Main Street Apartment Hotel

Summit Powder Mountain

RE: Responses to Planning Department Comments

Weber County Planning Department Review Comments and Responses.

EXHIBIT D.

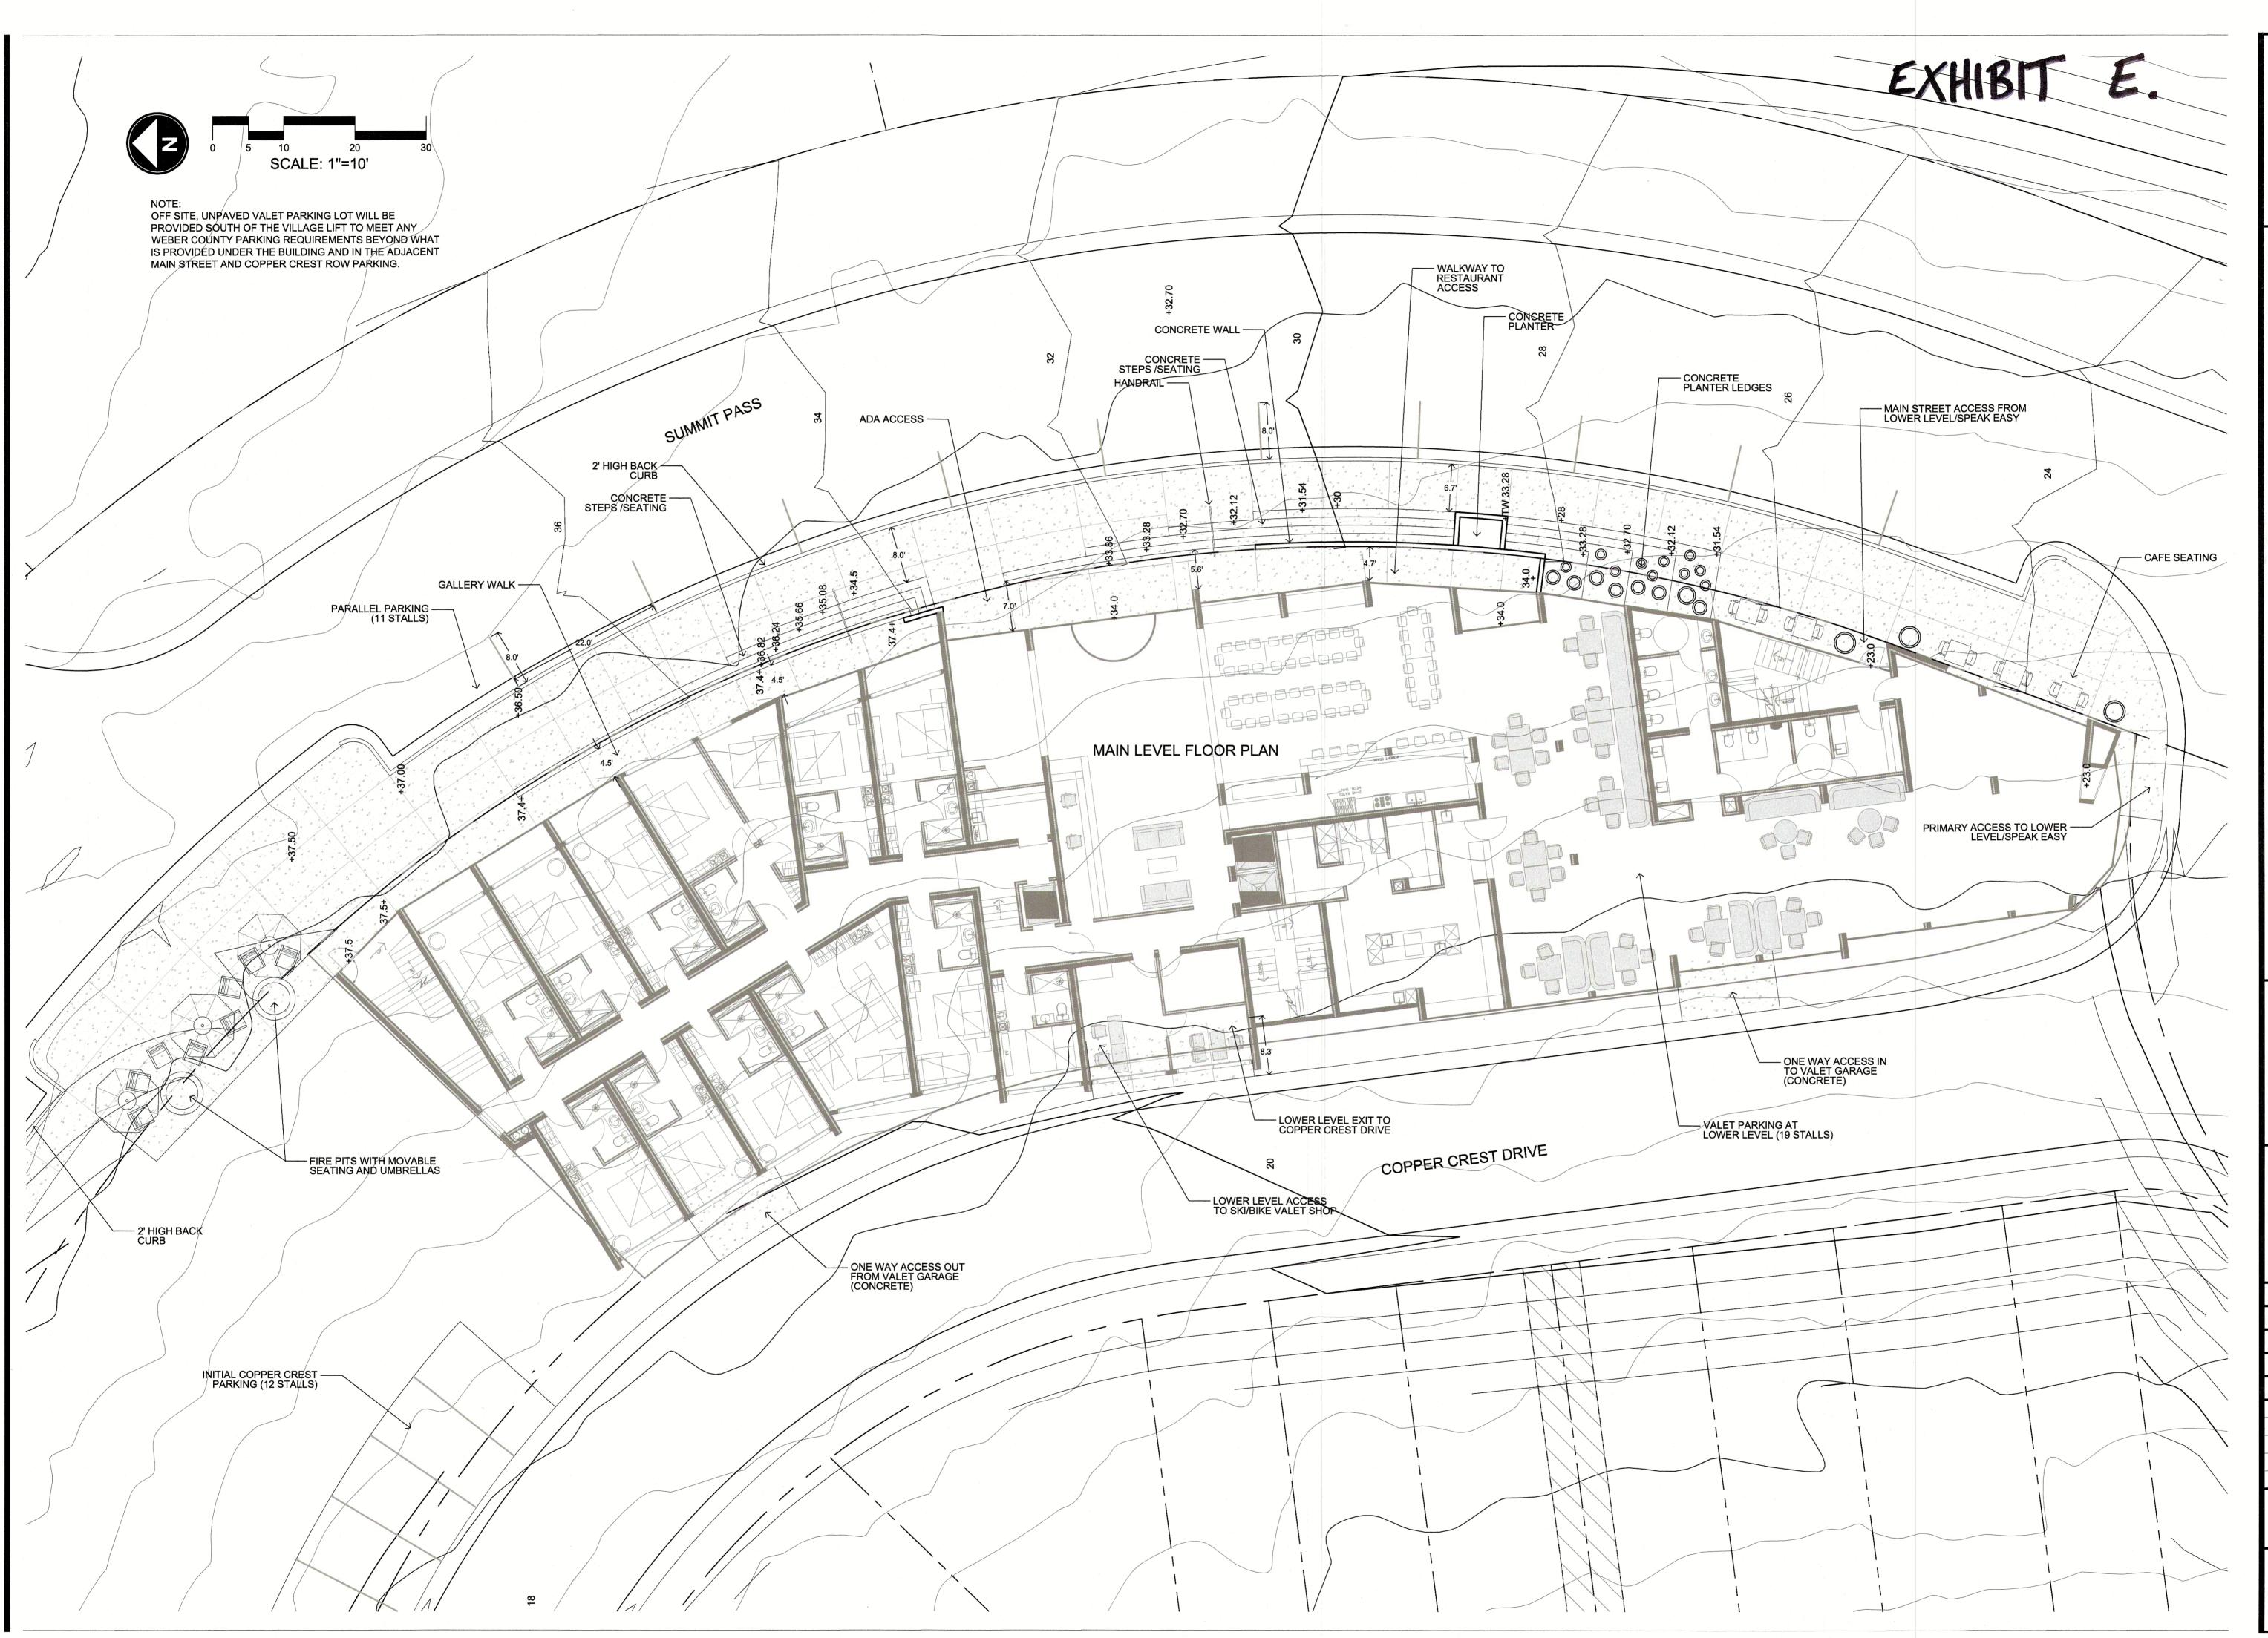
- 4. There is a 10-foot public utility easement on the plat. Will the building encroach on that easement? The propose of the easement is to protect the specified area from encroachments. The building will not encroach on the easement shown on the plat. Attached is Exhibit D showing the easement and its relationship to the footprint of the building. We do have our trash enclosure tentatively positioned on the easement but this can easily be modified to be located off of the easement if this is a concern.

L1.3

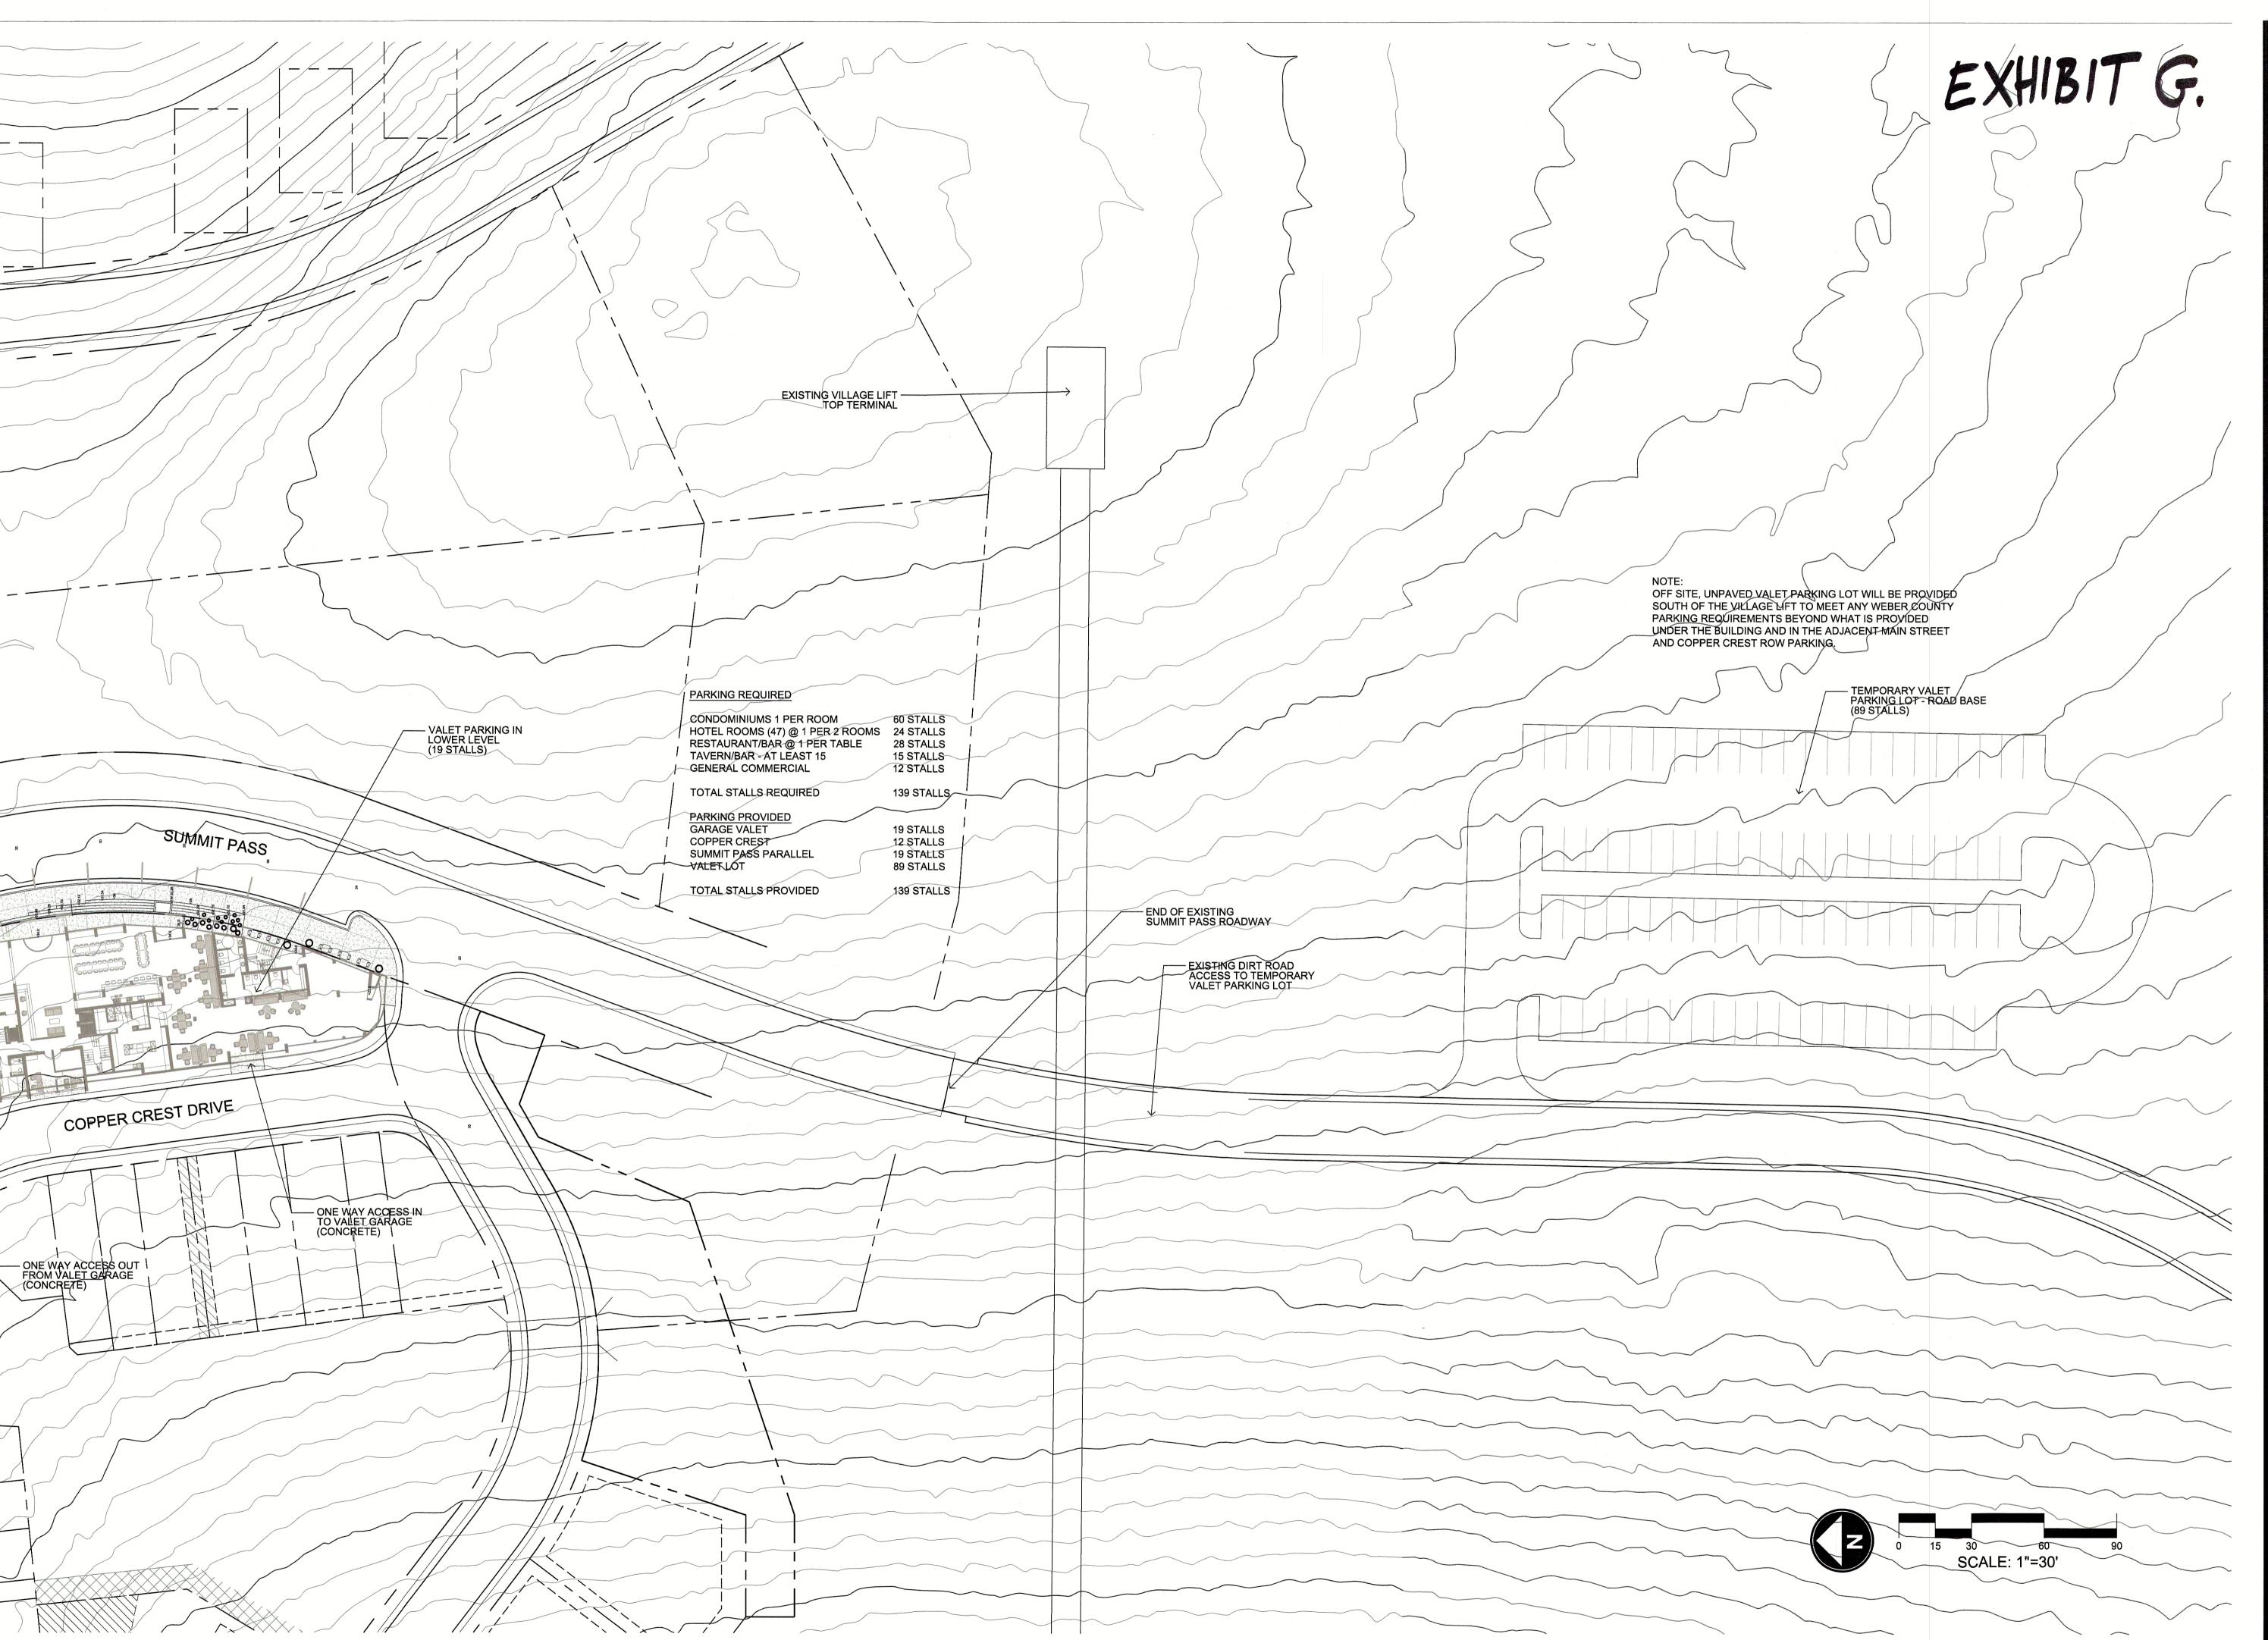
- 6. Please provide in greater detail, a site plan showing ground level outdoor improvement such as sidewalks. How will pedestrians on sidewalk be protected from street cars and parallel parking? Please address this for all sides of the building. Attached as Exhibit E are the requested details.

- (6) In addition to all required street improvements, high-back curb or other barrier, determined appropriate by Weber County Engineer, shall be installed to separate and sufficiently protect pedestrian areas or sidewalks from dangers associated with street travel lanes. On attached Exhibit E (the Detailed Site Plan) the applicant shows a 2' high back curb between the sidewalk and the road. The interface between the pedestrian walkway and the adjoining street that reflects the above request.

- (7) Pedestrian areas or sidewalks shall not be less than four and one-half feet in width. Please see attached Exhibit E that illustrates compliance that all sidewalks are a minimum of 4 and one-half feet in width.
